Outline Planning Application – LLFA Consultation Response

DATE:	02 December 2022	CONFIDENTIALITY:	Public
SUBJECT:	Consultation Response – S62A/2022/0012 - Land East of Station Road, Elsenham		
PROJECT:	Our Reference: 70084697 - Elsenham Stage 2	AUTHOR:	[REDACTED]
CHECKED:	[REDACTED]	APPROVED:	[REDACTED]

Essex County Council Lead Local Flood Authority have reviewed the FRA reference *4697-WSP-00-XX-RP-DR-0001-2.0* and produced a consultation response dated 24/11/2022, posing a holding objection to the planning application.

Figure 1 – Soakage testing location plan

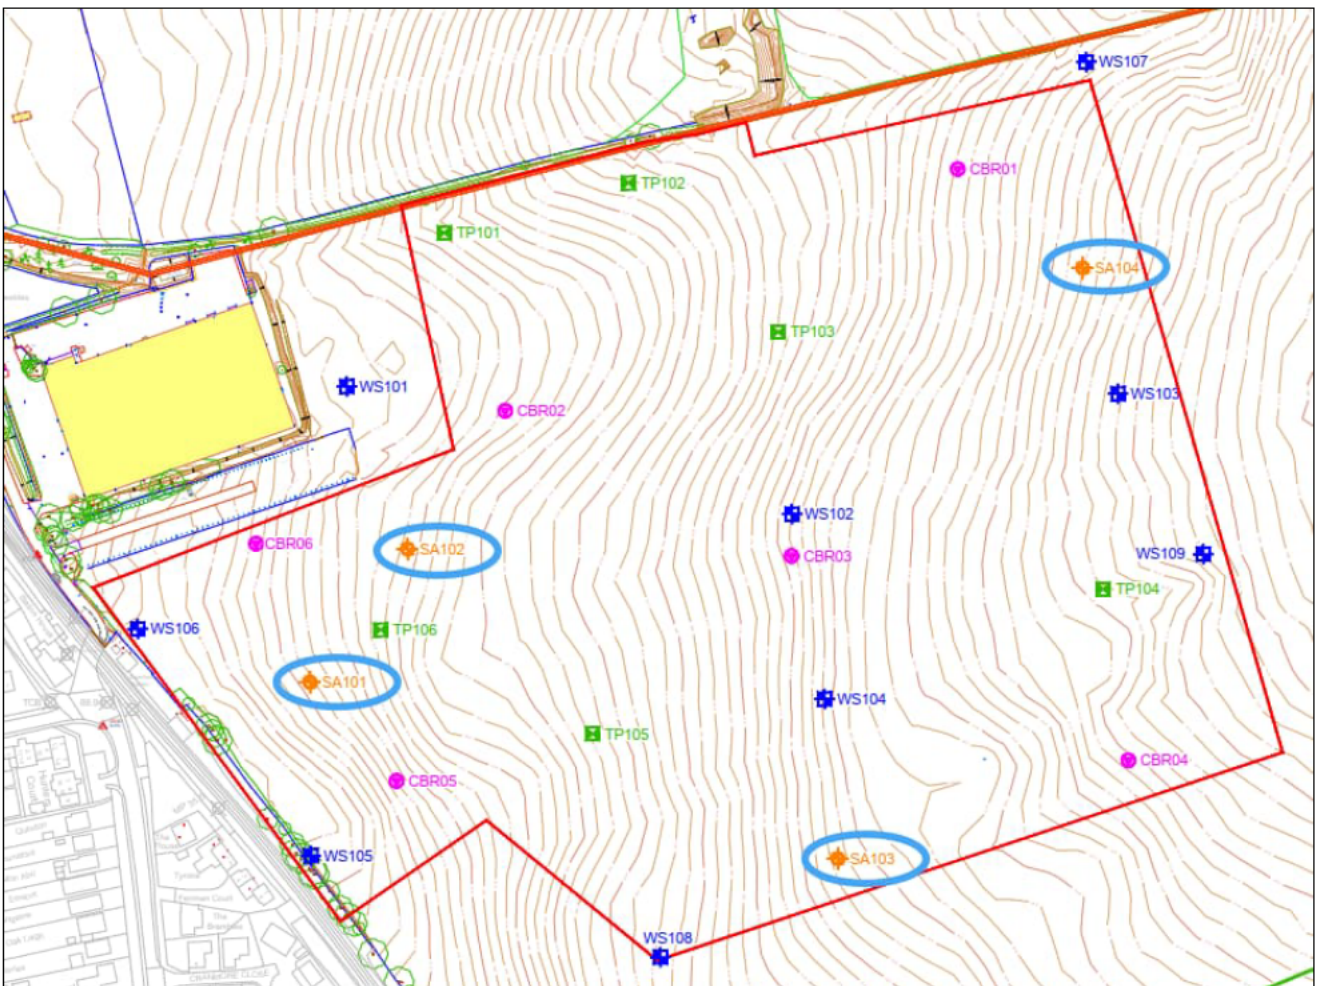
LLFA comment: The geotechnical site investigation report suggests that there are reasonable infiltration rates recorded beneath the central/southern portion of the site. This may lead to the possibility of shallow soakaways being possible and that further investigation will be required. Please clarify the reasons as to why this has not been proposed on site in line with the surface water hierarchy?

The Ground Investigation report reference 1921748-R02 (00) by RSK in Appendix B of the FRA shows four soakage tests in various locations across the site noted as SA101, SA102, SA103 and SA104. Results are summarised in Table 2 below.

Results show that three out of four of the soakaway locations failed the test in accordance with BRE 365, which indicates that infiltration would not be viable across most of the site. Only a small, isolated area within the Kesgrave Catchment Group along the southern boundary may be suitable for infiltration.

Due to limited viability of infiltration to ground, in accordance with precautionary principle set out within the NPPF, the outline surface water drainage strategy is based upon the principle of surface water disposal to an existing watercourse only.

Further limited testing will be undertaken post planning to refine the current baseline information, however with the information available to date, it should be noted that this will not change the over-arching drainage principles set out within the outline application, i.e. for any paved areas located within sufficient soakage zones, the proposed lined permeable pavement could be changed to un-lined to enable a quantum of water to discharge directly into the receiving sub-soil.

INSET A
TYPICAL PERMEABLE PAVING ARRANGEMENT
NOT TO SCALE

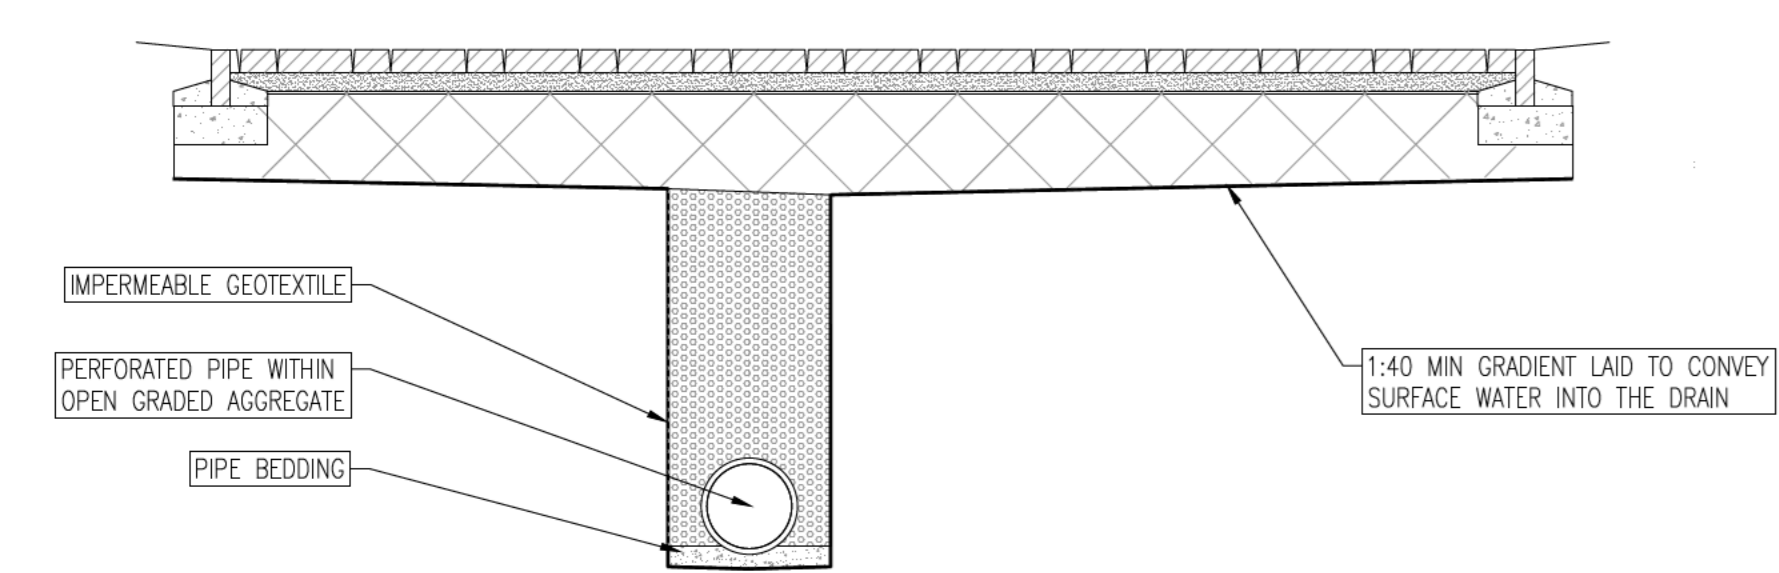
LLFA comment: Clarify the discharge location for permeable paving on site. Whilst permeable paving has been detailed within the FRA, the areas have not been input within the surface water design calcs.

As detailed in Note 10 of Drainage Strategy drawing 4697-WSP-00-XX-SK-D-0902-P01 shown in Appendix G of the FRA, the permeable pavement will be lined and discharge, via perforated pipework, to the proposed surface water system.

Proposed permeable paved areas are included in calculations in Appendix H of the FRA, as summarised on Table 1 of this Technical Note. The permeable pavement is included for conveyance and sediment control only and will not be used for attenuation storage. Therefore, calculations for the permeable pavement have not been included in the FRA.

To assist, a typical detail setting out the design intent of the lined permeable paving has now been added to the Drainage Strategy drawing 4697-WSP-00-XX-SK-D-0902-P02. Refer to Appendix A for details.

INSET B
SW OUTFALL ARRANGEMENT
SCALE 1:500

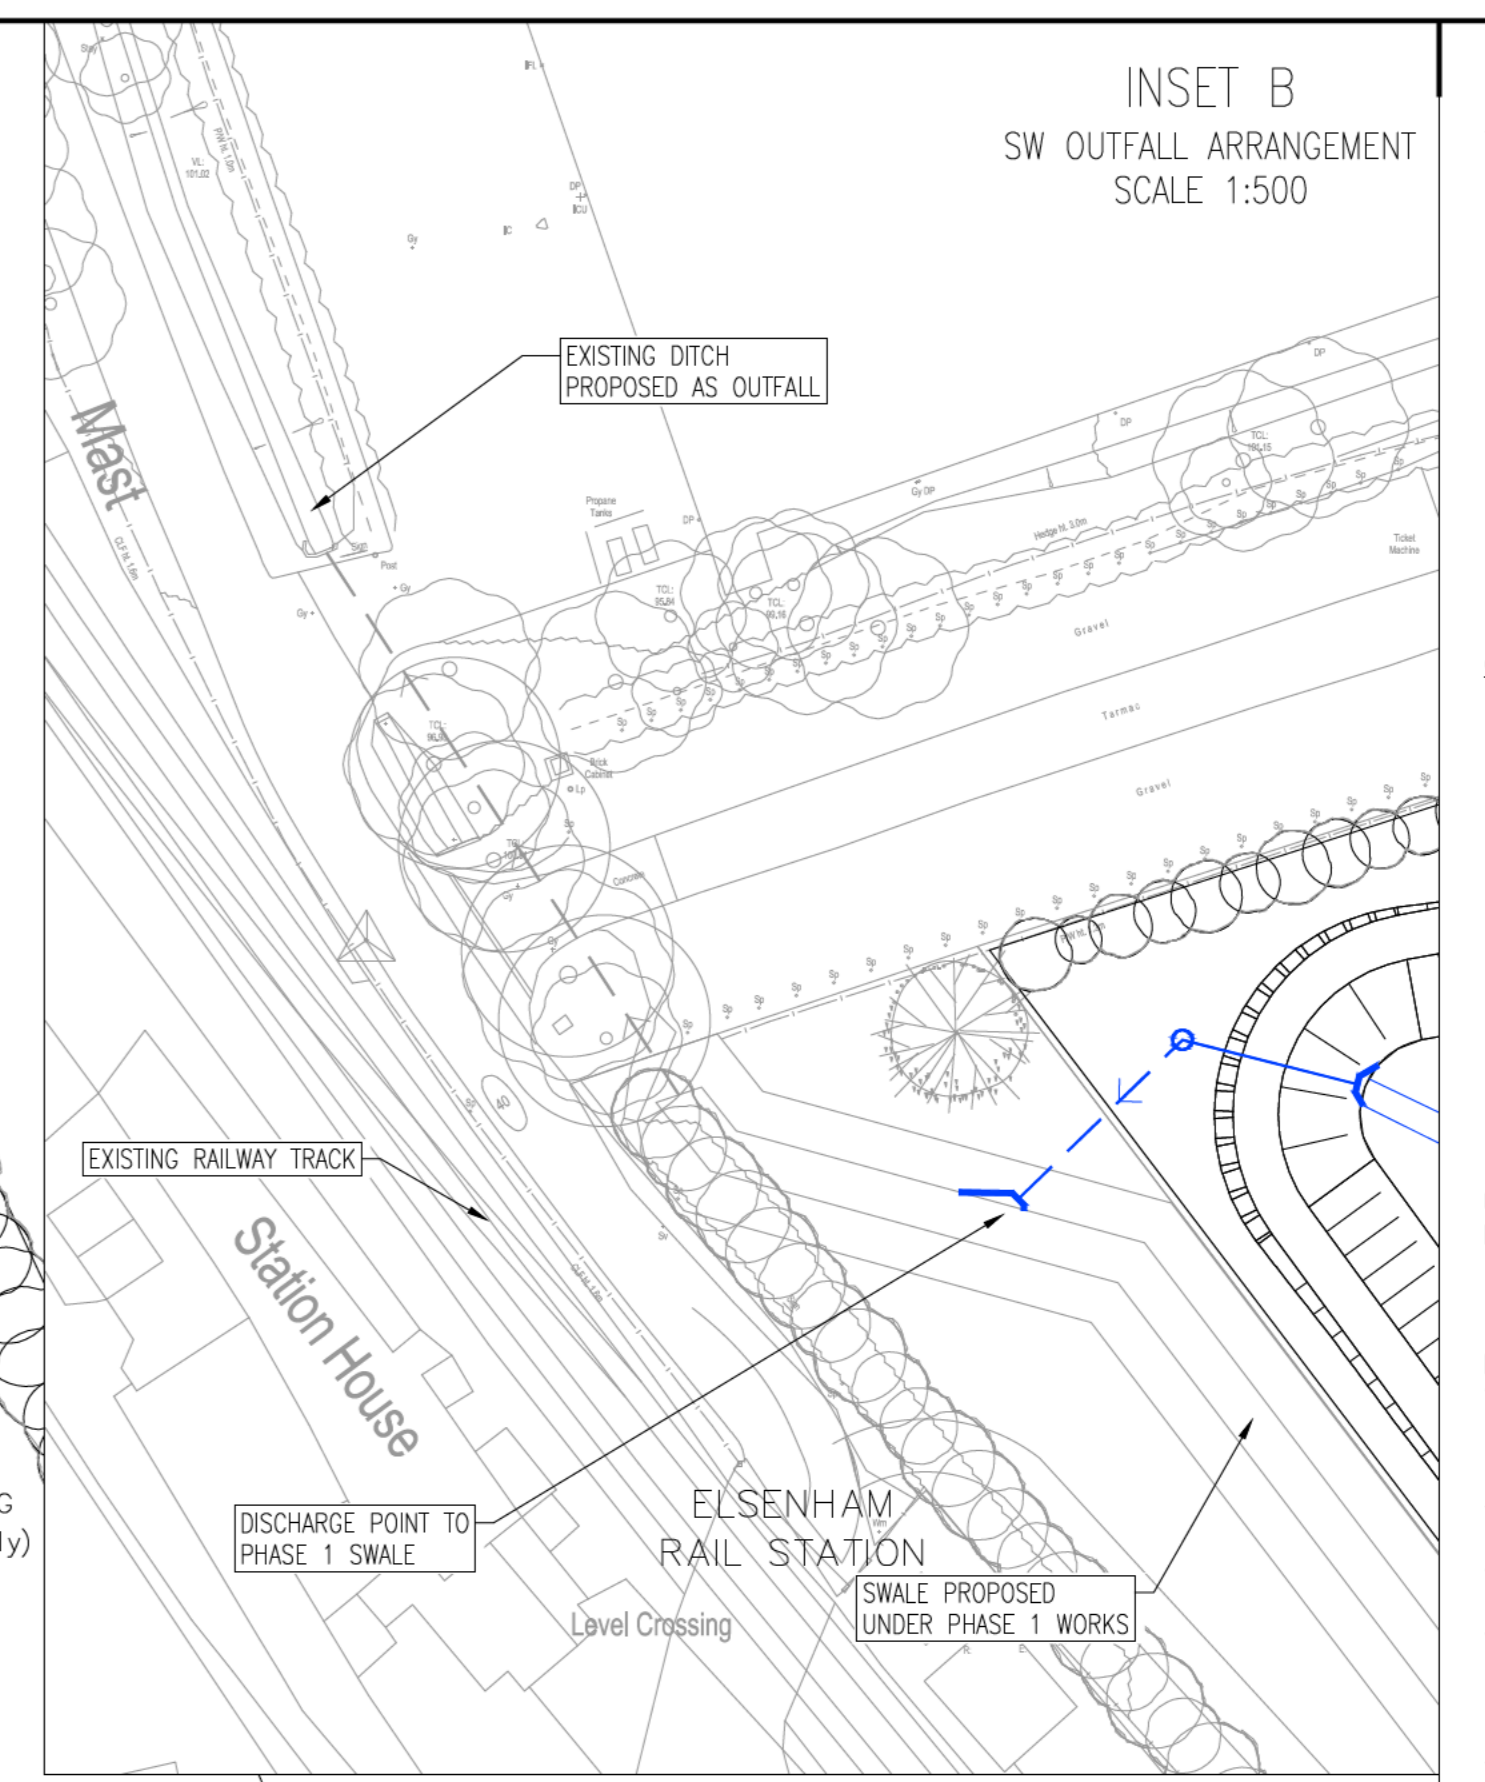
LLFA comment: In line with the Simple Index Approach for water quality the pollution hazard indices is incorrect in that due to the amount of dwellings proposed on site the traffic movements will be above 300 and as a result the hazard level will be classed as medium. As such there are not enough treatment stages proposed. I am aware that permeable paving is proposed in areas however this does not look to have been detailed with the SuDS mitigation indices.

Therefore, the combination of the detention basin which will accommodate low flow ‘rills’ and sediment forebays in conjunction with the swale (which provides additional passive treatment) demonstrates that the selected SUDS mitigates the “medium” pollution hazard level. Refer to Table 4 below for details:

For clarity, further detail has been added to the detention basin setting out the design intent of the low flow ‘rills’ and sediment forebays as shown on Drainage Strategy drawing 4697-WSP-00-XX-SK-D-0902-P02. Refer to Appendix A for details.
